Ascot Green West Planning Application 22/01971
Sunninghill and Ascot Parish Council Recommendations

Sunninghill and Ascot Parish Council has reviewed the above application and our response, as approved at our Planning Committee of 17th August 2022, is presented below.

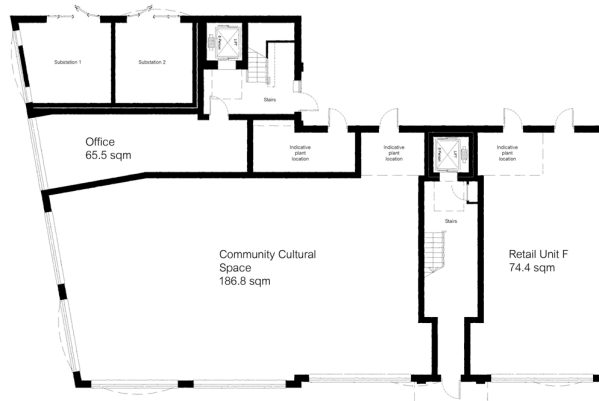
In particular, the proposal fails to deliver the Civic and Community Centre and Village Square in accordance with the community aspirations, as clearly set out in the above documents.

When preparing the 2018 Development Brief the developers asked their architect to prepare an outline layout for the civic and community centre / arts space. This layout was the basis for the area of 1,157 sqm GIA quoted in the resulting Development Brief and shown on the Illustrative Masterplan alongside the village square (section 5.1 and Fig 5.1). It was the stated intention of the three developers to vest these facilities in our Parish Council, being considered the only safe organisation to own and manage as we are around for the long haul. We assume that Ascot Central Car Parks were party to these decisions through their representative, Giles Perry.

The D&A Statement Part 2 includes a section on the evolution of the design from the 2018 Development Brief Illustrative Masterplan to the application proposals. This masterplan showed the Community Arts space and village square, but both disappeared in the next iteration.
